RELEASE AND SETTLEMENT AGREEMENT

1. Further Work. Morgan, through its contractor J&K Contracting, L.L.C. ("J&K"), will perform certain repairs to the Project as set forth in Exhibit 1 attached hereto, without cost to Polk County or Ankeny ("Further Work"). Ankeny has prepared a "Revised Set of Plans" which provide the specifications for the Further Work, attached hereto as Exhibit 2 and incorporated as though set forth fully herein. The Further Work will commence on or about July 30, 2018. All

ROCK CREEK LATERAL SANITARY SEWER

2	FILED 00001	1/12/00	11/12/00
1	00000	6/03/99	6/03/99
NAME	REVISION	DATE	BY
Engineer: CAP	Checked By: MJA	Scale: 1" = 20'	
Inspector: RAS	Date: 6/03/2009	Plot: Bk. #2	
Project No: 107008BF		Sheet D2.01	
File No: D-3123

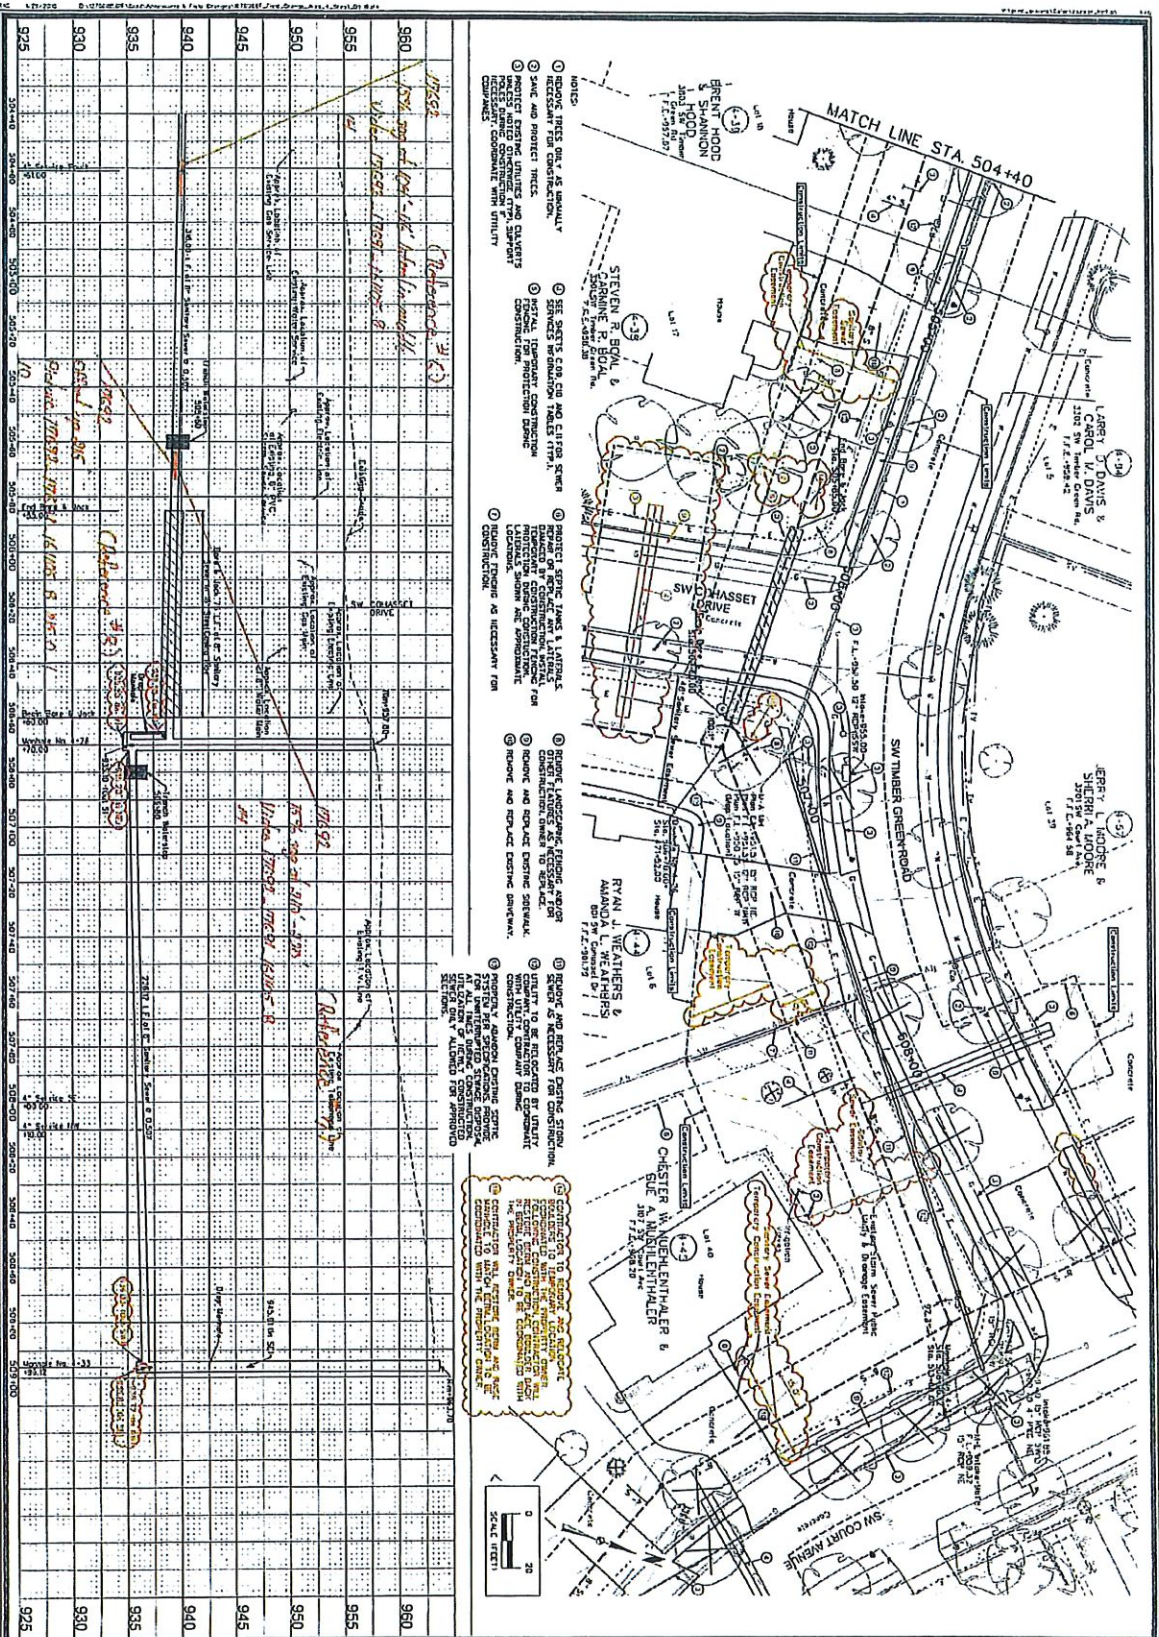
(Sheet D2.01) 16G 26 Plan Number 2-3/2-2 Concern 15% sag at 67'

- (1) The sag at this location is a marginal 10% sag in a single piece of pipe and would not be fixable. You would not be able to get the belly out and if you rotated pipe it would create a high spot which would create a new problem. We will chase this, and it is already functioning.

(Sheet D2.01) 16G 26 Plan Number 2-3/2-2 15% sag at 95'

- (2) The sag at this location is a marginal 10% sag single piece of pipe and would not be fixable. You would not be able to get the belly out and if you rotated pipe it would create a high spot which would create a new problem. We would chase this, and it is already functioning.

(Sheet D2.01) 16G 26 Plan Number 2-3/2-2 20% sag at 187'-214'

- (3) This spot will need to be dug up and the two joints that are low will need to be raised to minimize the sag. OK.

(Sheet D2.01) 16G 25 Barrels sections leaking

- (4) This concern will be addressed by sealing up barrel sections and prevent infiltration. OK.

Please plan to excavate and repair this sag.

Please plan to excavate and repair this sag.

Sheet D4.16

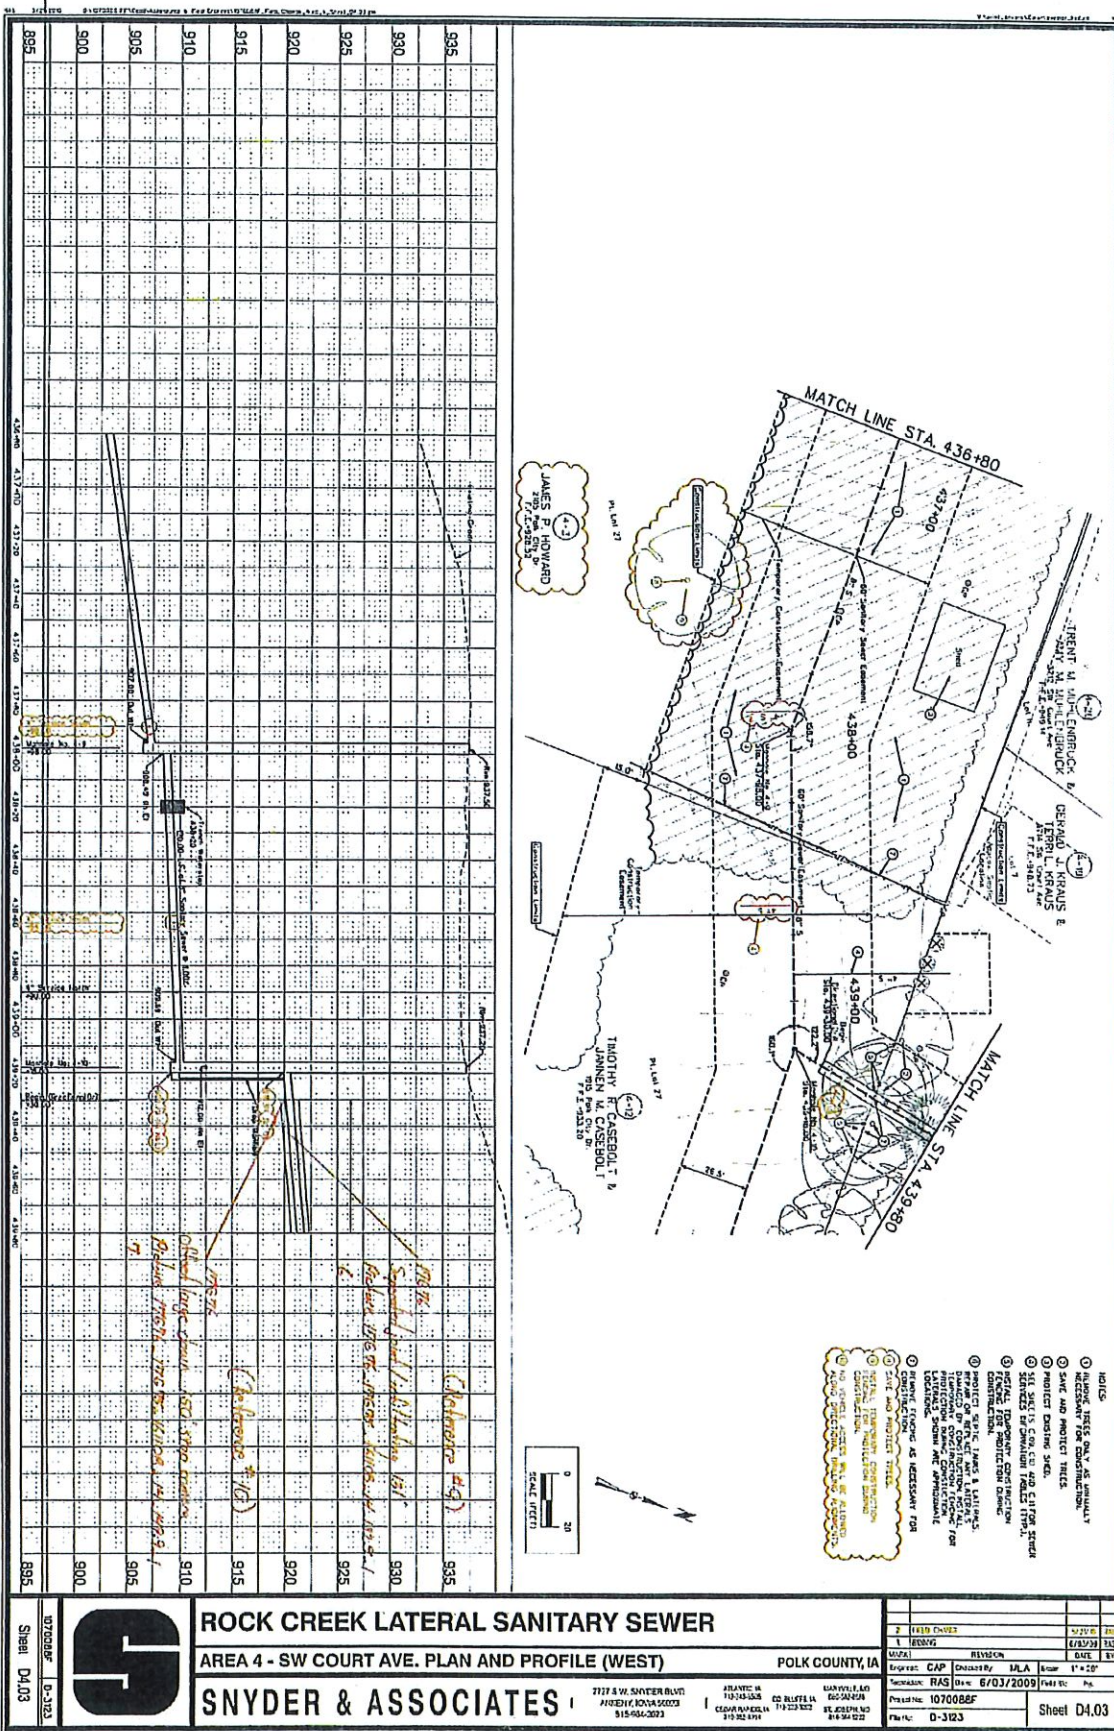
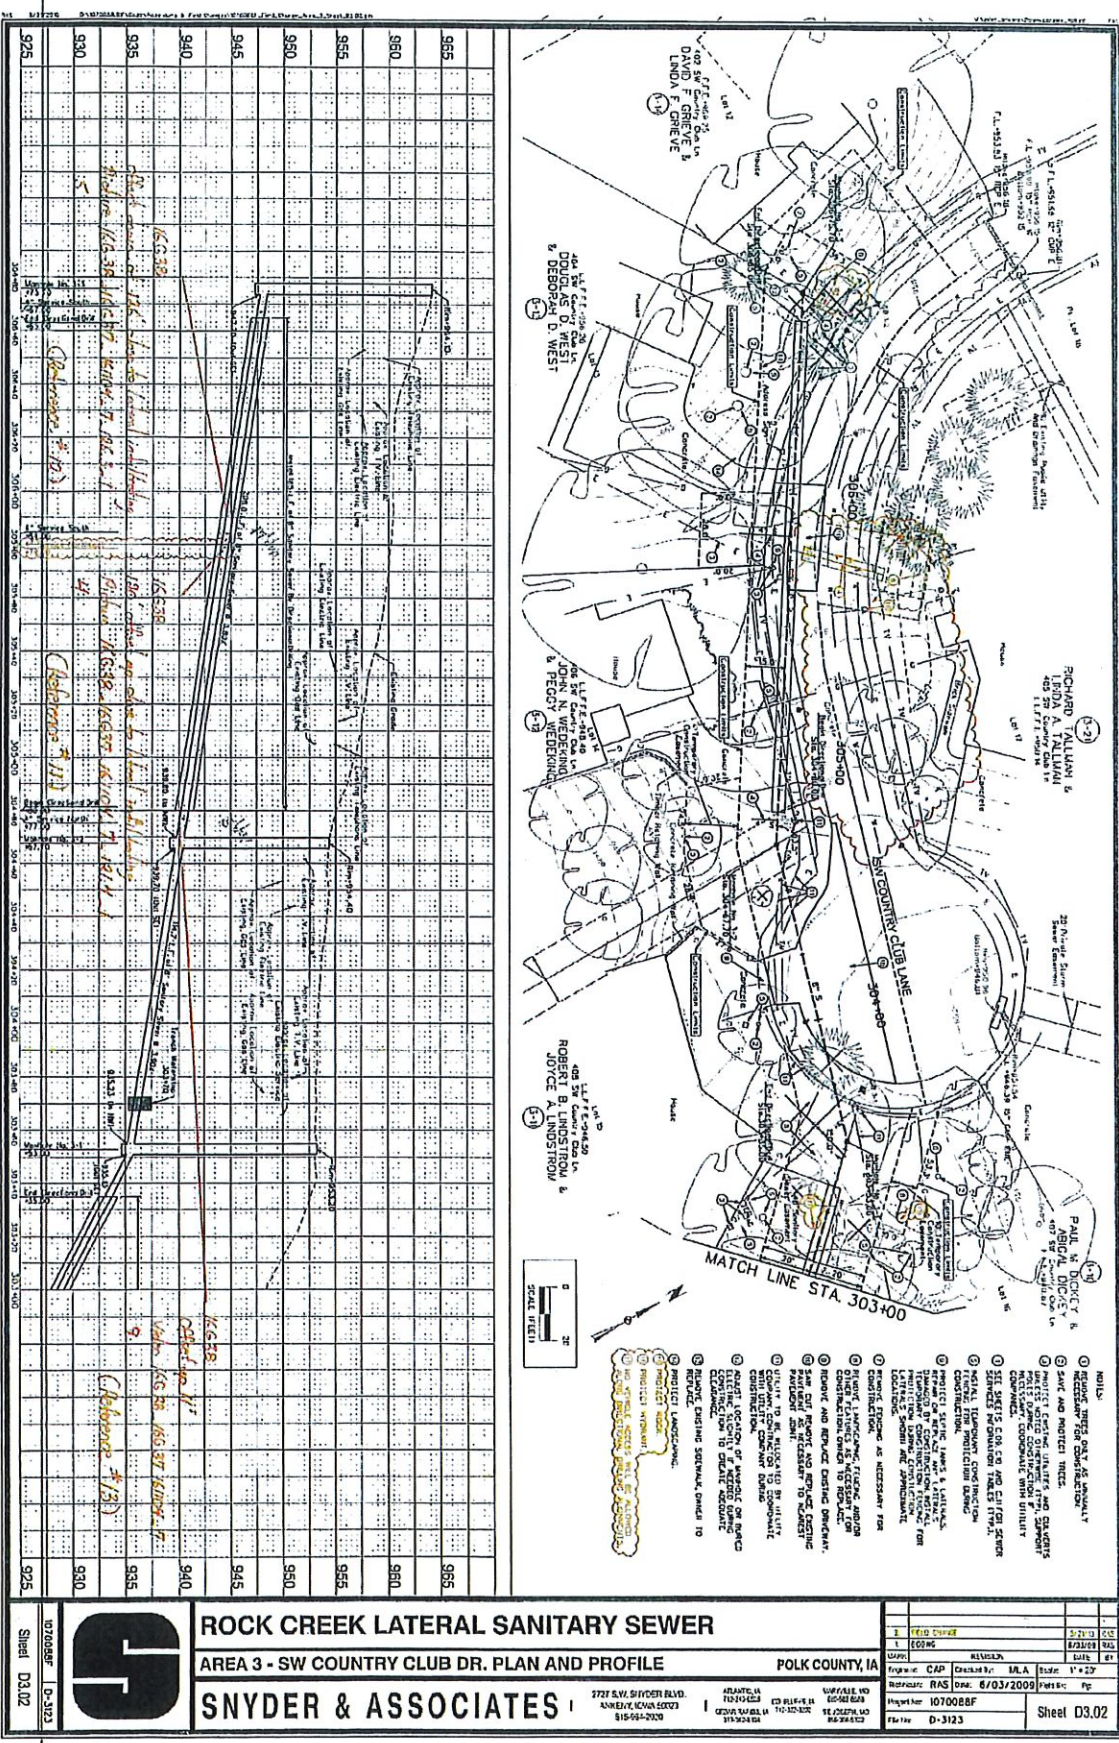
(Sheet D4.16) 17G 92 Plan Number 4-32/4-26 15% sag at 210'-220'

- (7) This spot will need dug up and the offset joint at 215' will need to be addressed which will minimize the sag from 210'-220'. Do not excavate as we do not wish to disrupt this property.

Sheet D4.16) 17G 92 Plan Number 4-32/4-26 offset up 215'

(8) This spot will get resolved while doing 17G 92 Plan Number 4-32/4-26 sag at 210'-220' Please install interior pipe patch to provide smooth transition for offset joint.

Sheet D3.02

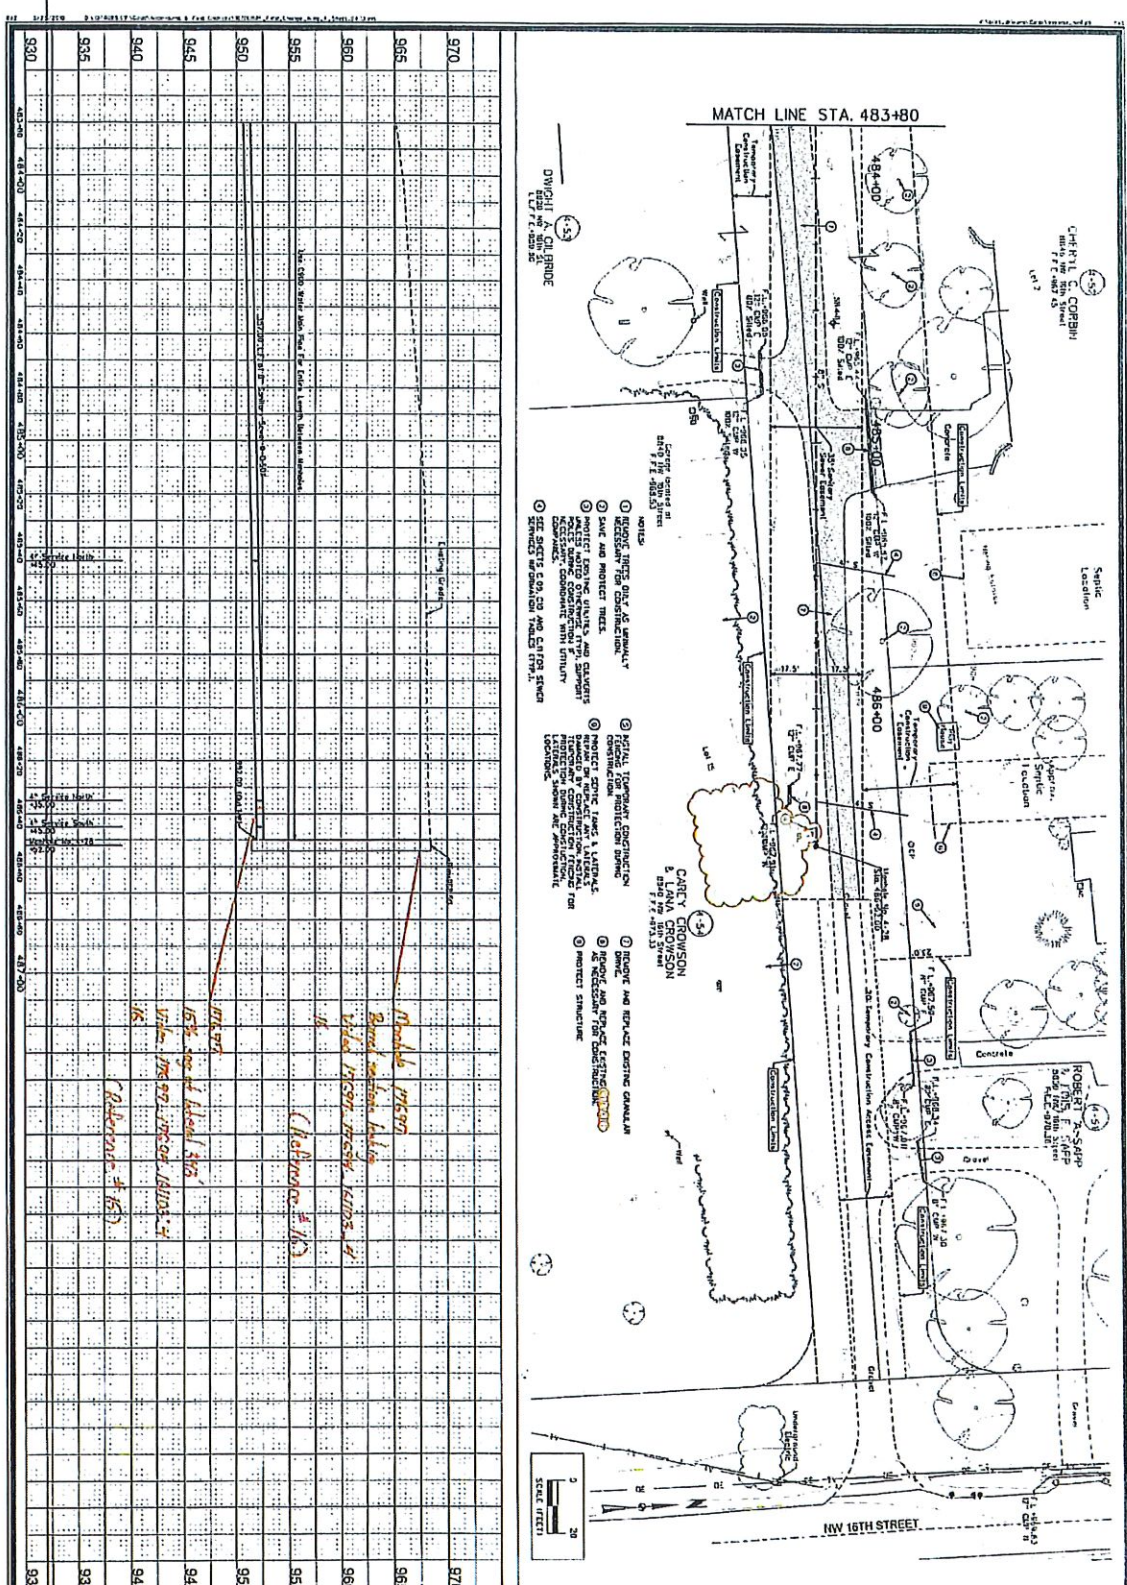
(Sheet D3.02) 16G 38 Plan Number 3-3/3-2 120' offset/infiltrating close to lateral at 2 o'clock

(11) The minor offset will need addressed because of the infiltration the joint and infiltration will be fixed using a packer ball. Please install interior pipe patch to provide smooth transition for offset joint.

(Sheet D3.02) 16G 38 Plan Number 3-3/3-2 offset down at 126 close to lateral at 11 o'clock/infiltrating

(12) The minor offset will need addressed because of the infiltration the joint and infiltration will be fixed using a packer ball. Please install interior pipe patch to provide smooth transition for offset joint.

(Sheet D3.02) 16G 38 Plan Number 3-3/3-2 Offset up 11'

(13) A fix is not warranted at this location. The offset pipe is due to a romax connection there is no restriction with the flow line and there is no infiltration and is functioning. OK.

Sheet D4.05

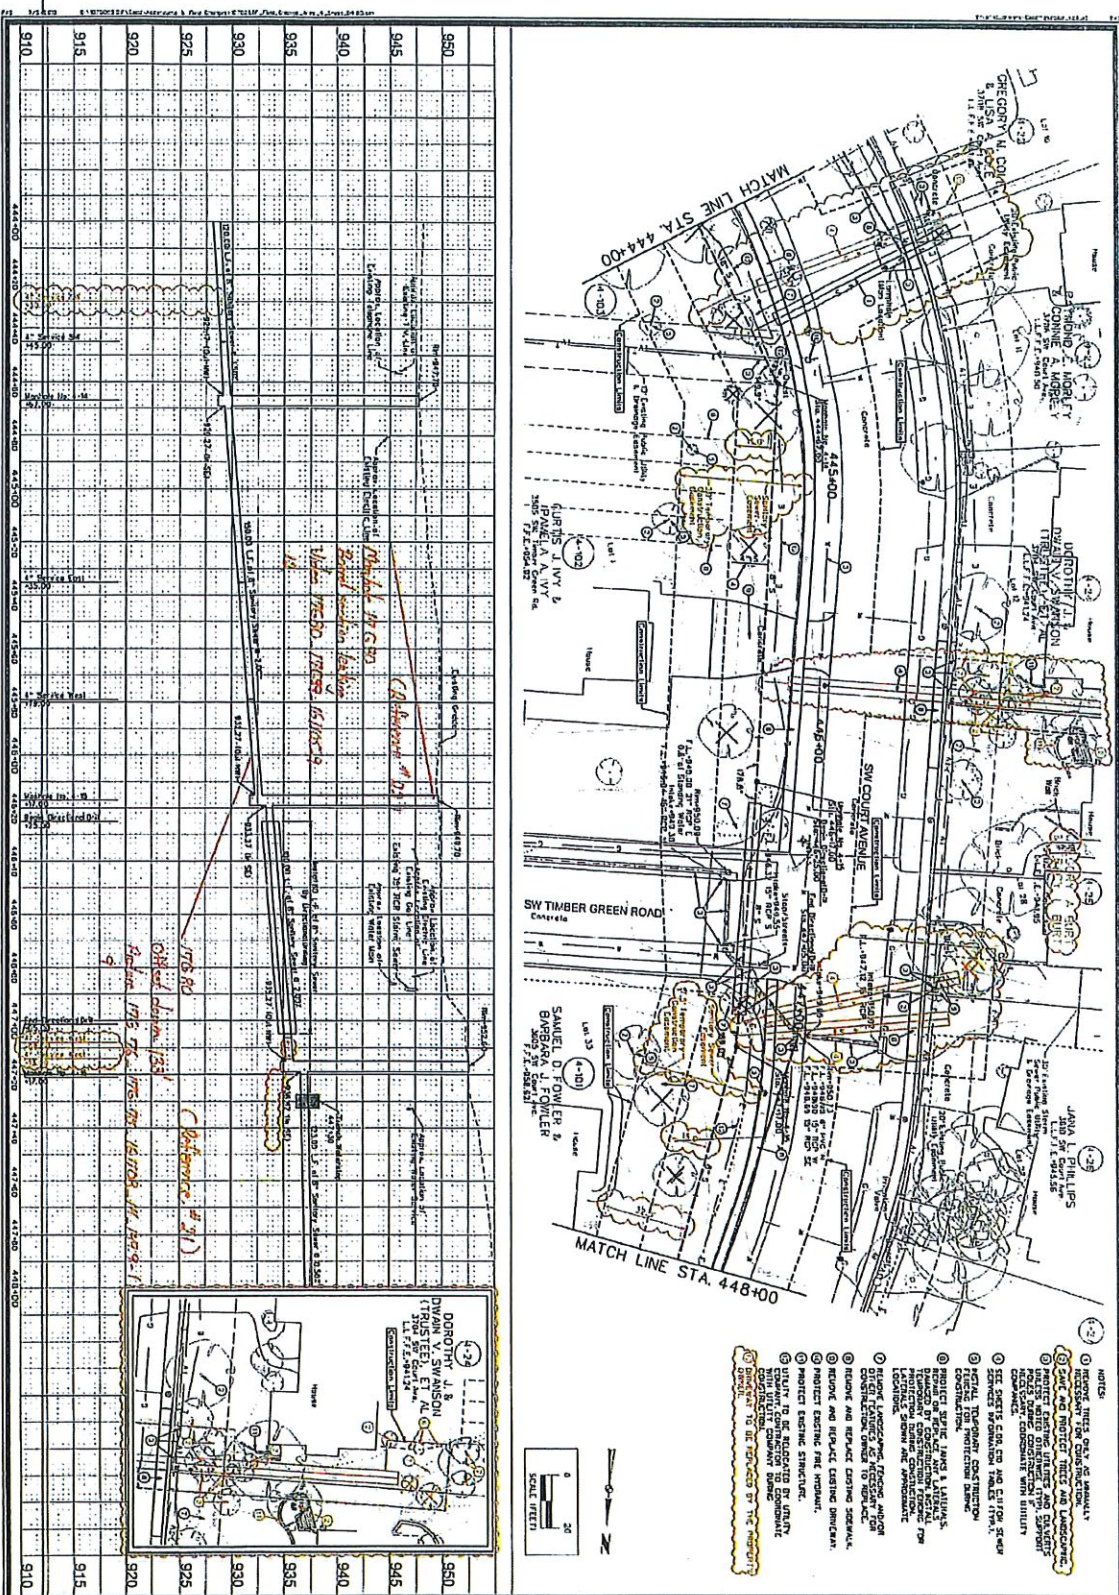
(Sheet D4.05) 17G 80 Plan Number 4-15/4-14 Offset down 133'

- (21) A fix is not warranted at this location. There is no restriction or infiltration and it is functioning with no issues. **OK.**

(Sheet D4.05) 17G 80 Expose manhole at surface and fix invert to provide positive flow

- (22) This concern will be addressed by grinding down the invert to get positive flow. **A smooth flow line from pipe invert to pipe invert must be maintained to fix this issue.**
